APPLICATION NO.	FILING DATE	FIRST NAMED INVENTOR	ATTORNEY DOCKET NO.	CONFIRMATION NO.
09/589,881	06/09/2000	Jeongmin Moon	3430-0105P	1734
7590 05/13/2010 Birch Stewart Kolasch & Birch LLP P O Box 747 Falls Church, VA 22040-0747				
EXAMINER NGUYEN, HOAN C				
ART UNIT 2871		PAPER NUMBER		
MAIL DATE 05/13/2010		DELIVERY MODE PAPER

Office Action Summary**Application No.**

MOON, JEONGMIN

DETAILED ACTION

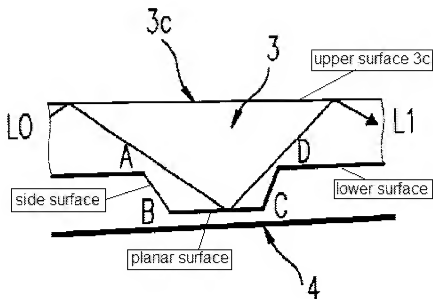
Claims 1, 10-11 and 21 amended on 04/27/2009 and filed on 03/15/2010 contain the new subject matter: "a size of the plurality of convex portions increases with increasing distance from the light source". This new subject matter never states in the original disclosure (the original drawings, the original specification and the original claims), which was originally filed on 06/09/2000.

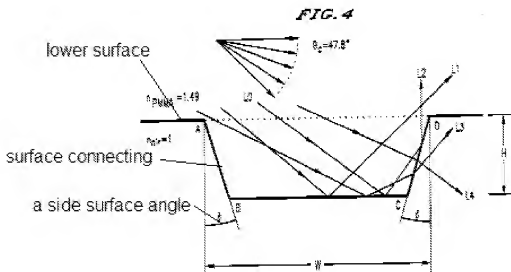
- o a lower surface having a plurality of convex portions extending from the lower surface, each of the convex portions having a substantially planar surface which is substantially parallel to the lower surface, and a side surface connecting the planar surface and lower surface, and a side surface angle δ between the lower surface and a surface connecting the planar surface of the convex portion is about 90° since a side surface angle $\delta = 0^\circ$ or 2° (col. 7 lines 5-6).

- the plurality of convex portions have the same side surface angle δ with each other.
- light reflected along an orthogonal direction L2/L3 to the liquid crystal display device is uniform (to emit primary light inputted from the side end plane of the light guide uniformly, in abstract and col. 1 lines 27-28) according to Figs. 5 ($\delta = 0^\circ$) or Fig. 6 ($\delta = 2^\circ$) or Fig. 7 ($\delta = 5^\circ$).
